**CALIFORNIA COASTAL COMMISSION**

STAFF REPORT: APPEALDE NOVO HEARING

APPEAL NO.: **A-1-MEN-01-043**

PROJECT DESCRIPTION: **Construction of a 2,550-square-foot, 18-foot-high, single-family residence with a 625-square-foot detached garage, onsite sewage disposal system, extension of utilities, and installation of 2,500-square-feet of paving for a driveway.**

SITE PLAN

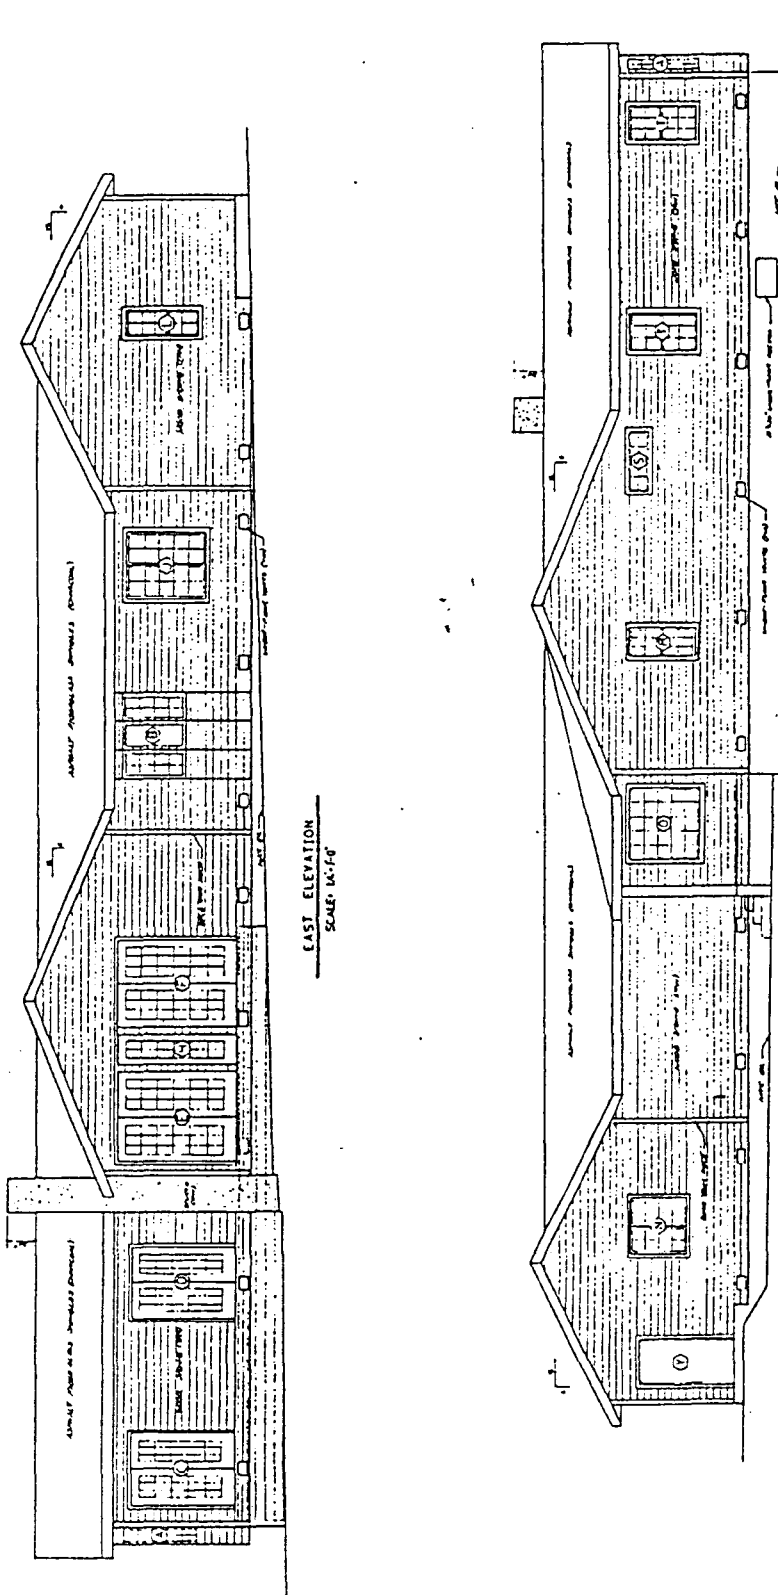
The garage would also need to be relocated approximately 25 feet to the northeast to clear area for the relocated residence and provide a ten-foot separation between the structures, consistent with uniform building and fire codes adopted by the County. Similar repositioning would also be necessary for the proposed driveway. However, as shown in Exhibit 3, much of the available space into which the structures could be further set back has been proposed as the locations for wastewater disposal and stormwater infiltration systems. Notwithstanding the need to develop required wastewater and drainage facilities, there appears to be adequate area on the parcel to reconfigure the improvements to provide a 25-foot setback between proposed structures, the bluff edge, and the blufftop projection of the back of the sea caves, comply with zoning district

yard standards, and accommodate development of requisite wastewater and drainage facilities. For example, it would be feasible to move the house and garage to meet the setback requirements in a manner that would not require moving the proposed primary and reserve septic system areas should the applicants choose to do so. In such a case, the house and garage could be relocated to north-central portion of the lot. This would also have the added benefit reducing the amount of impervious surface by shortening the required length of the driveway needed for accessing the garage.

Special Condition No. 1 requires the submittal of revised site plans showing the proposed development setback 25 feet from the bluff edge or from the blufftop projection of the back of all parts of the underlying sea cave walls, whichever is further landward. Special Condition No. 2 requires the submittal of final foundation, construction, and site drainage plans that incorporate all recommendations of the submitted geotechnical report intended to avoid creating or contributing to geologic hazards. Special Condition No. 3 requires recordation of a deed restriction stating that no shoreline protective device shall be constructed on the parcel, that the landowner shall remove the house and its foundation when bluff retreat reaches the point where the structure is threatened, and that the applicant accepts sole responsibility for the removal of any structural debris resulting from landslides, slope failures, subsidence, or erosion of the site. Special Condition No. 4 requires recordation of a deed restriction stating that the applicant acknowledges and assumes the inherent and extraordinary risk of developing the blufftop property and waives and indemnifies the Commission against any claim of liability.

- A. PRIOR TO ISSUANCE OF COASTAL DEVELOPMENT PERMIT NO. A-1-MEN-01-043**, the applicant shall submit revised site, landscaping, and erosion and runoff control plans to the Executive Director for review and approval. The revised plans shall substantially conform with the site plan and landscaping plan submitted to the County of Mendocino Department Planning & Building Services on February 12, 2001 and May 17, 2001, respectively, and received by the Commission on August 2, 2001 as Exhibits C, H, I, and J, respectively, of the June 28, 2001 staff report contained in the County's public record for the project, except that the plans shall also provide for the following changes to the project:

**Comparison of cave setback recommended by project geologist and blufftop/cave setback per staff recommendation**

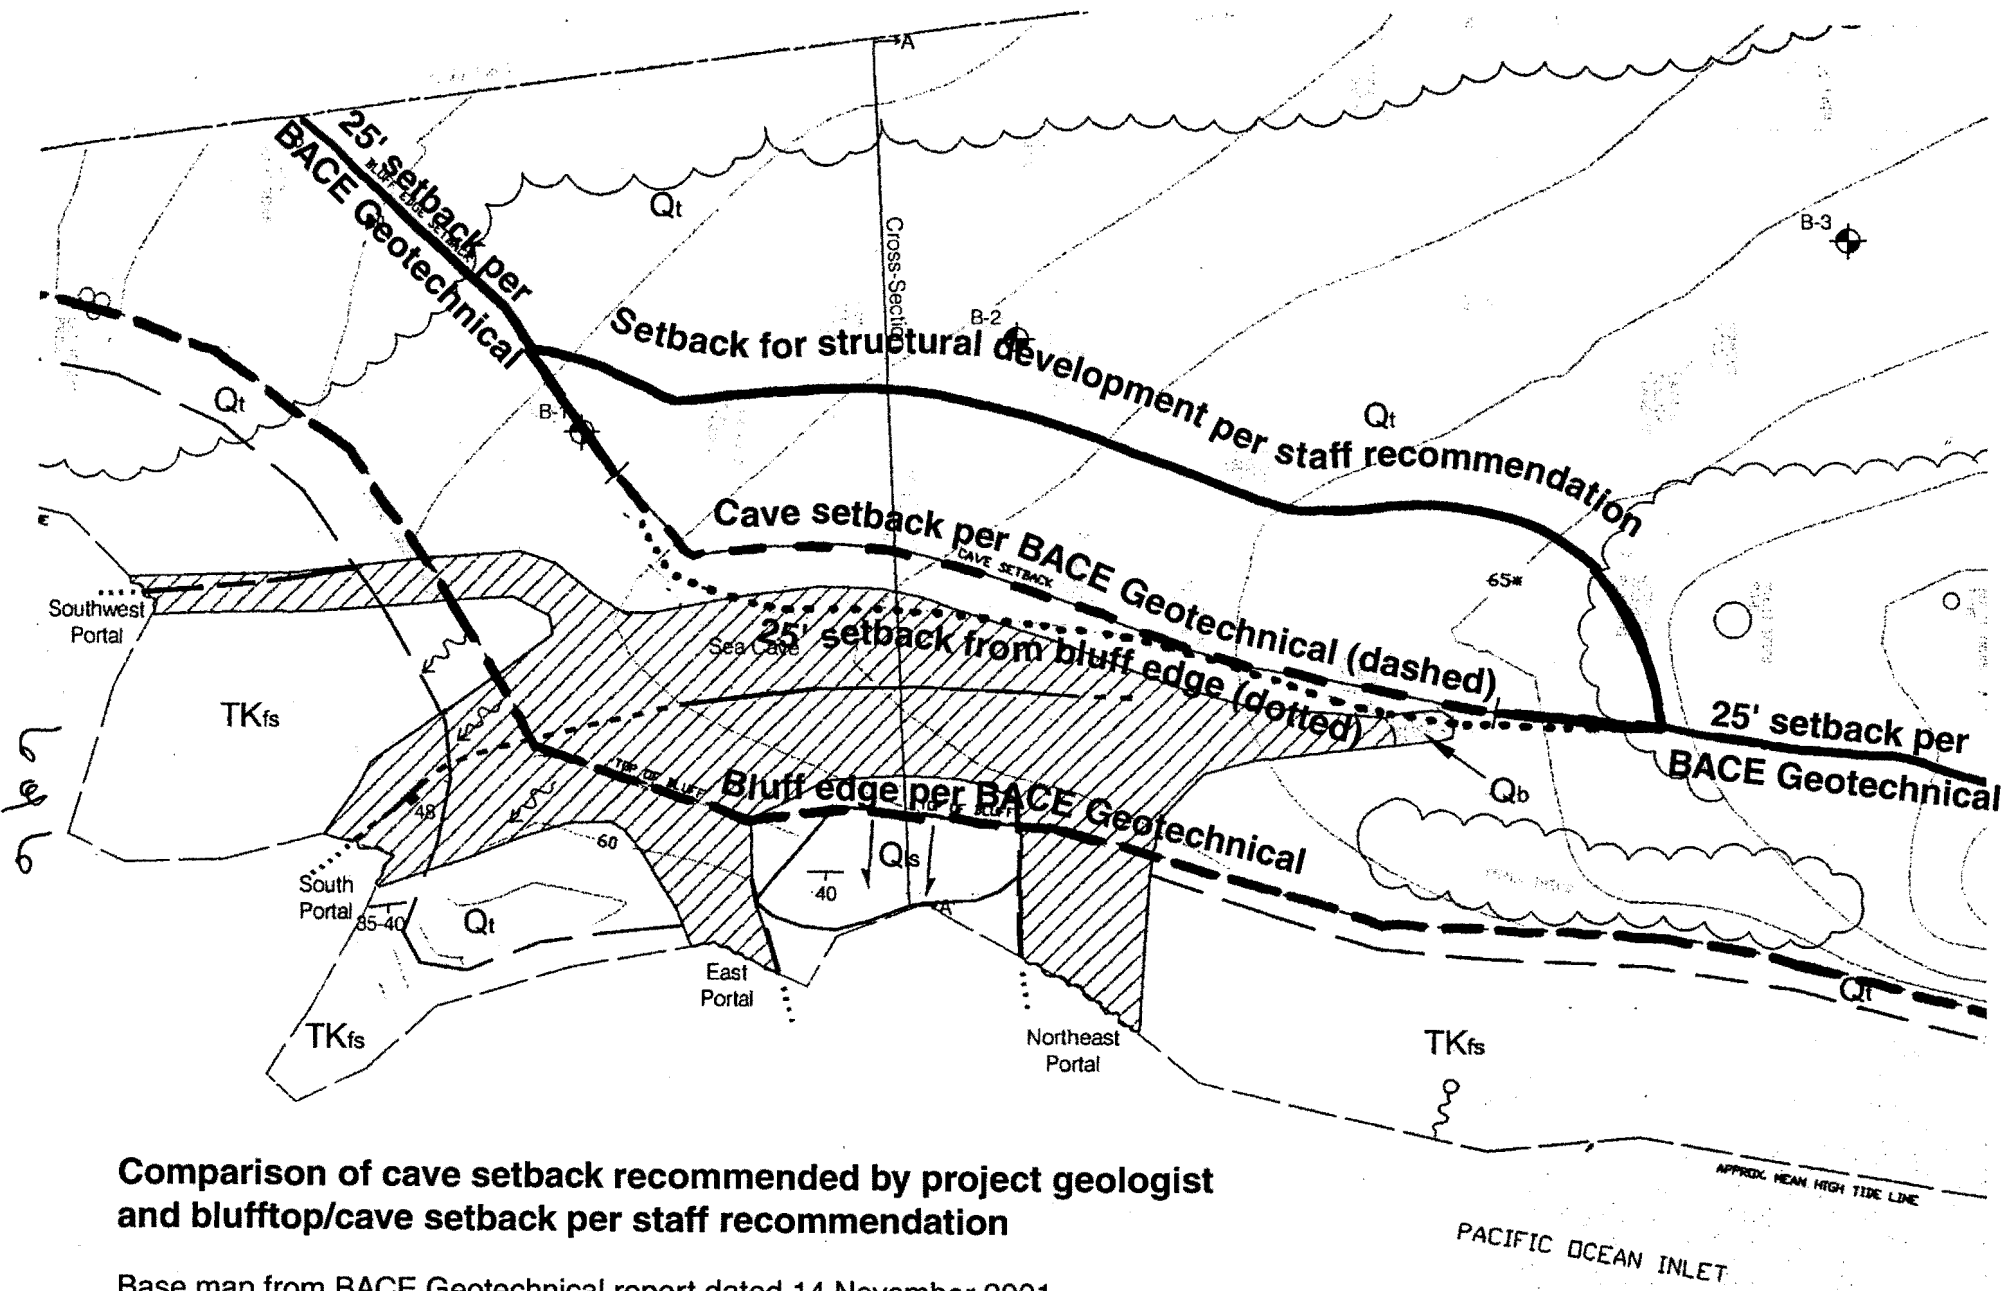
Since the sea cave may be expected to fail within the project life, a five-foot setback from the rear wall of the cave was recommended. The resulting "cave setback," although apparently intended to yield a conservative setback from the cave, varies from 0 to only about 8 feet landward of a 25-foot setback line from the edge of the bluff [Exhibit No. 8]. No explanation was provided for why five feet was considered an appropriate setback from the cave.
